July 29, 2013

Motor Business Division

**Notice of Change in the Shape of Outer-Base Type Mounting Frames, an Option for the Shin-G Series Compact AC Geared Motors**

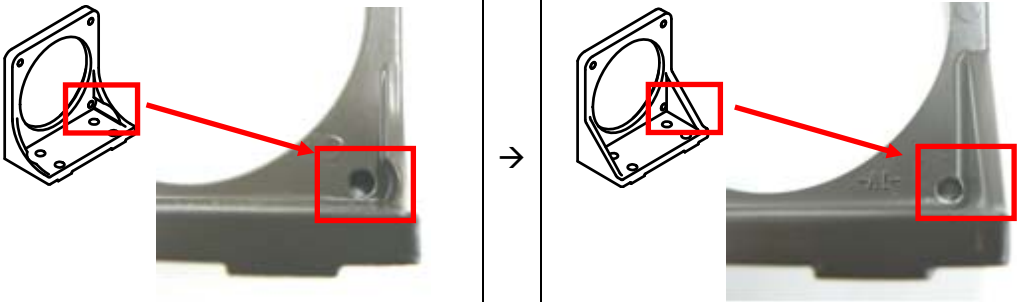
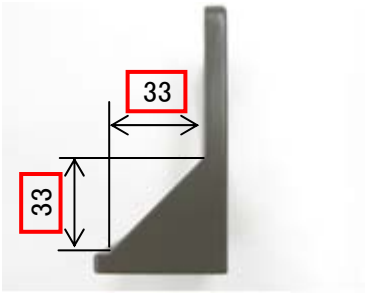
- Target Model: The outer-base type mounting frames M9B2, an option for the Shin-G Series Motors with a 90mm-square flange
- Reason of the change: Productivity improvement associated with local procurement in China
- Details of the change:

Current part (made in Japan)		Changed part (made in China)
	→	
Shape of rib base: Round	→	Shape of rib base: Linear
	→	
Shape of rib sidewall: Round	→	Shape of rib sidewall: Linear

- Schedule: Products manufactured from August 2013
- Others: Environmentally hazardous substances were taken into consideration when choosing this product as it was done with the conventional product.
